UNITED STATES PATENT AND TRADEMARK OFFICE

APPLICATION NO.	FILING DATE	FIRST NAMED INVENTOR	ATTORNEY DOCKET NO.	CONFIRMATION NO.
10/822,567	04/12/2004	Jimmie D. Burrow	125447-1005	2641

Office Action Summary	Application No. 10/822,567	Applicant(s) BURROW ET AL.	
	Examiner GERARD T. HIGGINS	Art Unit 1794

DETAILED ACTION

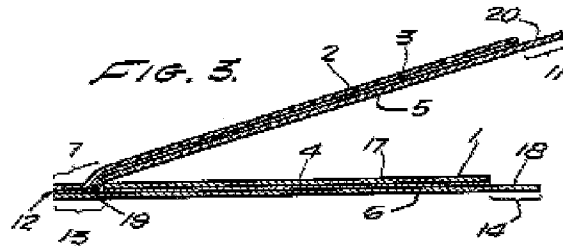
With regard to claims 37 and 38 Jones discloses the device of Figure 3.

The device is a protected label, which can be used as a luggage tag. The device is comprised of a member **2** and **3**, a transparent film sheet which is clearly flexible as seen in Figure 3 and an image sheet **1**, which is made of paper, another flexible material (col. 1, line 60 to col. 2, line 38). Clearly when this laminate has been sealed after peeling of the layer **5** and subsequent bonding of the layers **2** and **3** onto the layer **1** and the backing layer **6** the member layer **2** and **3** will have a substantially planar indent or debossment of a thickness that is about equal to the thickness of the image sheet **1**, which is identical to that claimed. The Examiner deems that the adhesive of Jones will form a bond analogous to applicants' bonding by RF radiation.

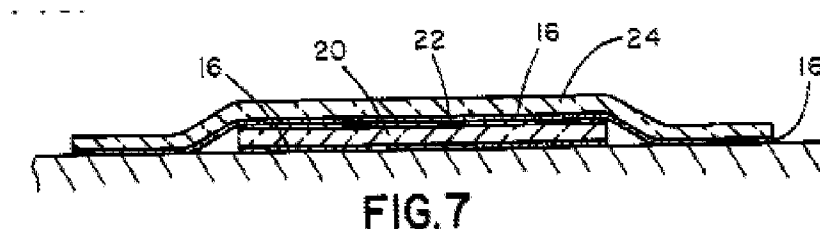
With regard to claims 27, 28, 37, and 38, Ambridge et al. disclose the device of Figure 7.

The device is a label, and therefore it may be used as a luggage tag. It is comprised of a flexible and indentable member **24** and an image sheet or flexible sheet of plastic

material **20**, which is the same material as the portion **24** (col. 2, lines 2-54). Clearly from the Figure the member **24** has a substantially planar debossed indentation that is at least equal to the thickness of the image sheet **20**. The image sheet is bonded to the member in the indentation. The Examiner deems that the adhesive **16** of Ambridge et al. will form a bond analogous to applicants' bonding by RF radiation or by applying energy.

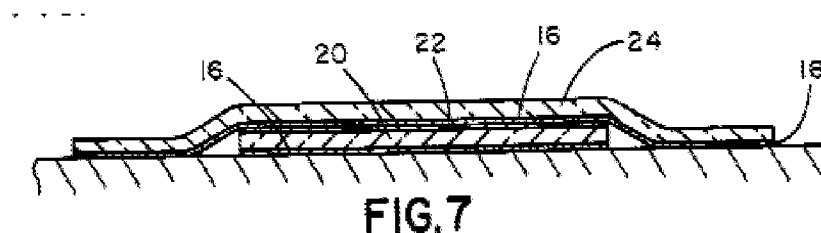
With regard to claims 29 and 34, Ambridge et al. disclose the device of Figure 7.

The device is a label, and therefore it may be used as a luggage tag. It is comprised of a flexible and indentable member **24** and an image sheet or flexible sheet of plastic material **20**, which is the same material as the portion **24** (col. 2, lines 2-54). Clearly from the Figure the member **24** has a substantially planar debossed indentation that is at least as great as the thickness of the image sheet **20**. The image sheet is bonded to the member in the indentation with the image side (first side) **22** facing the member. The substrate to which the member and image sheet is attached is a laminate sheet covering said image (please see Figure 7); however, Ambridge et al. fail to disclose that the second face, opposite of the image side (first face), is the side bonded to the member **24** and that the substrate is a transparent laminate sheet.

It would have been obvious to one having ordinary skill in the art at the time the invention was made to reverse the orientation of the image sheet **20** such that the

image side (first side) **22** was not the side contacting the member **24**. It would have equally been obvious to one having ordinary to make the image seen from either side, which therefore means it would have been obvious to make the substrate to which this label was attached was also transparent. The end use of the device would dictate which side one would want to see the image; and clearly one could expect predictable results by merely reversing the orientation of the image sheet **20** and making the substrate transparent.
